WATER QUALITY MEMORANDUM

Utah Coal Regulatory Program

SUBJECT: Third Quarter 2016 Water Monitoring, Andalex Resources, Centennial Mine, C/007/0019, Task ID #5319

Figure 1. Surface to ground water levels, 1989-2016

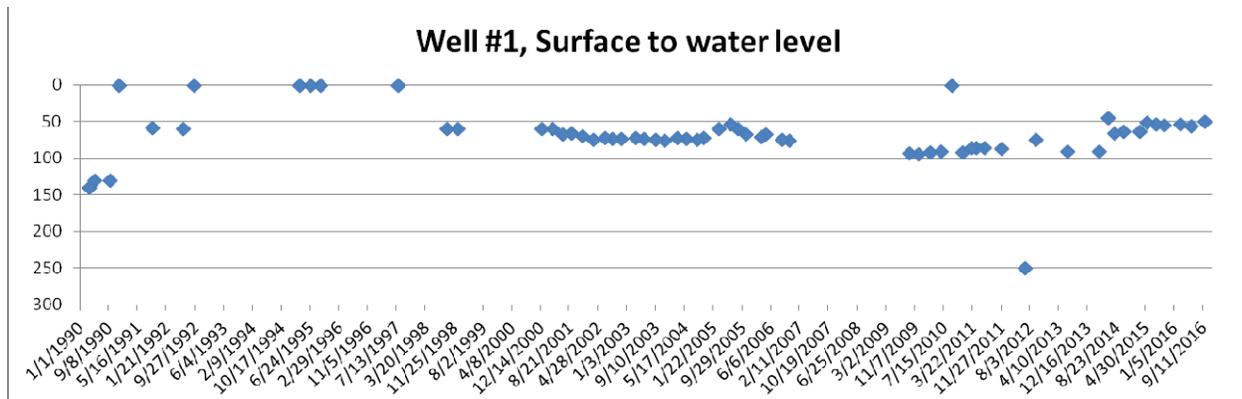
Wells YES NO

The continued examination of the depth to water at Well #1 is required.
